APPENDIX C6
COMMENTS RECEIVED

Comments received on EIA Report to be included
in the Final EIA Report

ACCEPTANCE OF THE FINAL SCOPING REPORT FOR THE PROPOSED TAFELKOP SOLAR PHOTOVOLTAIC FACILITY AND ITS ASSOCIATED ELECTRICAL INFRASTRUCTURE ON PORTION 3 OF THE FARM GRASS PAN 40 WITHIN THE RENOSTERBERG LOCAL MUNICIPALITY IN THE NORTHERN CAPE PROVINCE

COMMENTS ON THE DRAFT SCOPING REPORT FOR THE PROPOSED TAFELKOP SOLAR PHOTOVOLTAIC (PV) FACILITY AND ITS ASSOCIATED INFRASTRUCTURE ON PORTION 3 OF THE FARM GRASS PAN 40 IN THE RENOSTERBERG LOCAL MUNICIPALITY IN THE GREATER PIXLEY KA SEME DISTRICT MUNICIPALITY, NORTHERN CAPE PROVINCE

Scale: 125 000
Projection: GCS_WGS_1984
Map Ref: Crossroads Green Energy Cluster

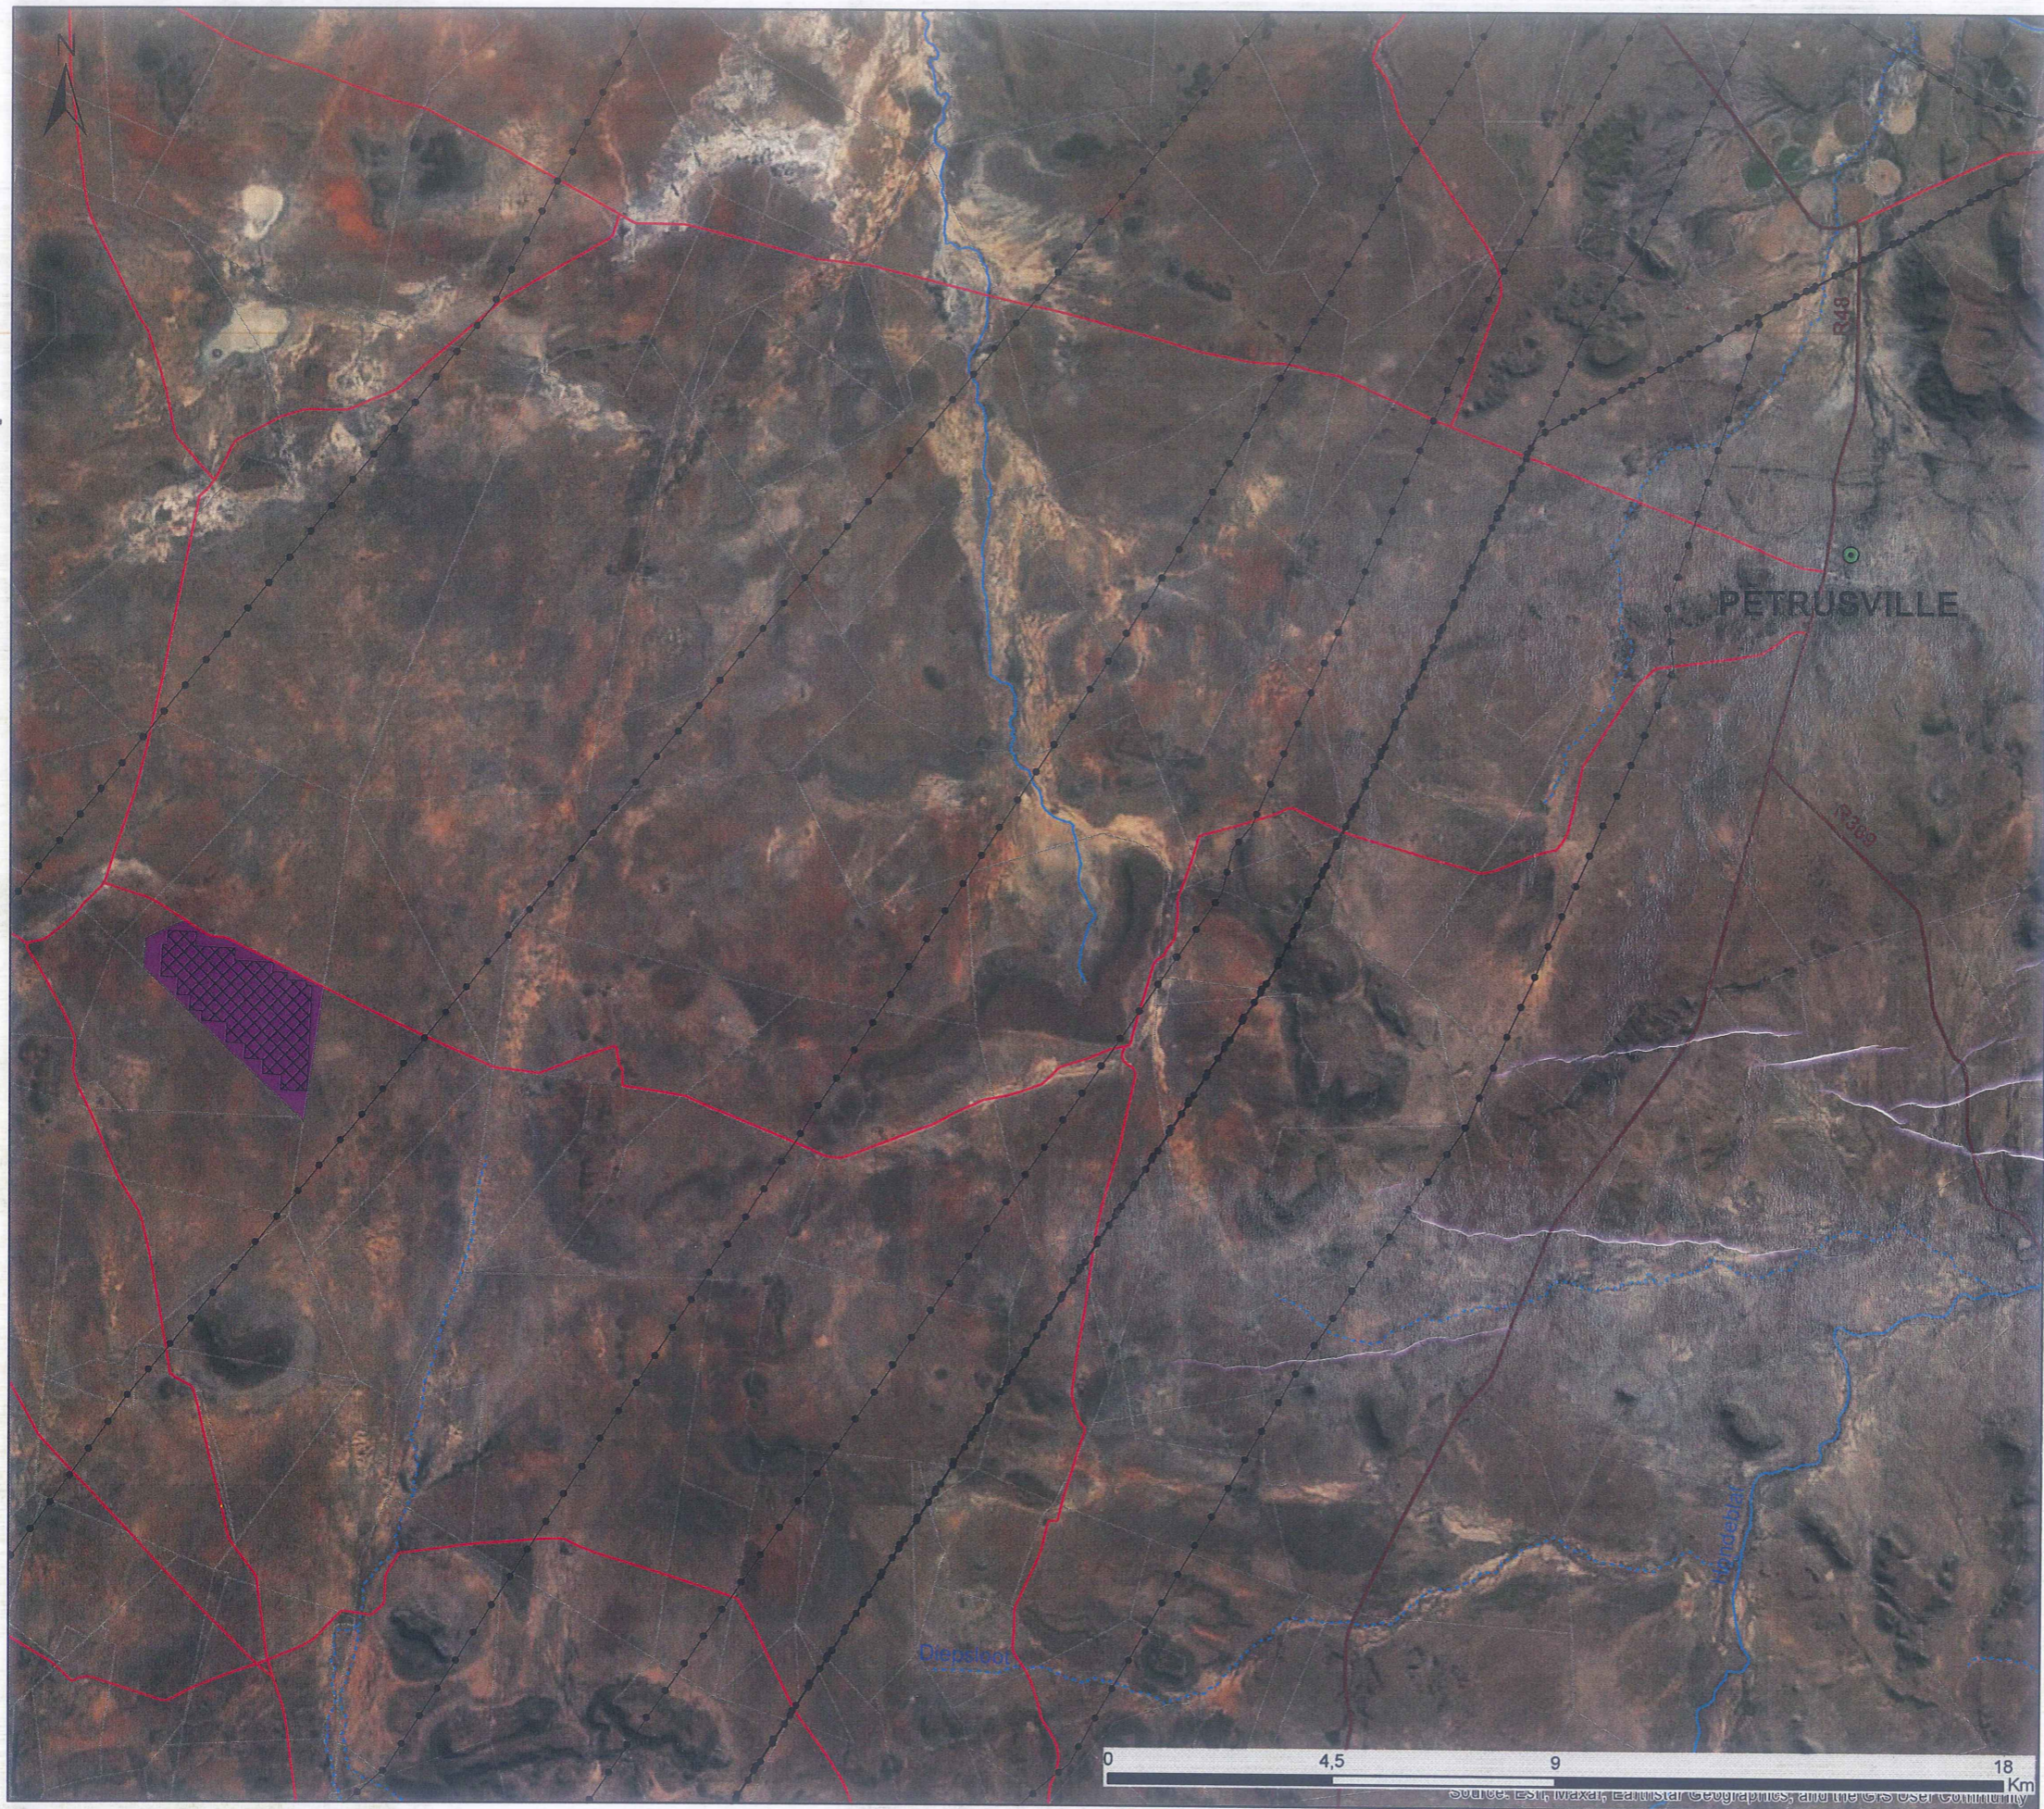
TELKOM SA. LIMITED DECLARATION
NO COMPANY PLANT IS AFFECTED BY
THIS PROPOSAL.

Aerial Plant - At points of crossing, the overhead power lines should cross above the communications lines in accordance with and clearances stipulated in the Occupational Health and safety Act no 85 of 1993, Machinery regulations 20 – Crossings, and Electrical Machinery Regulations 15 – Clearance of Power Lines. If the specifications could not be met, all deviation costs will be for the applicant's account. We also refer to section 25 of Electronic Communication Act 36 of 2005.

Paragraph 2.4.1 of the Code of Practice stipulates the minimum acceptable horizontal separation between power and the communication lines and where this cannot be met, the design of the power line is also stipulated. This could apply between the attached plans and these requirements should strictly be adhered to.
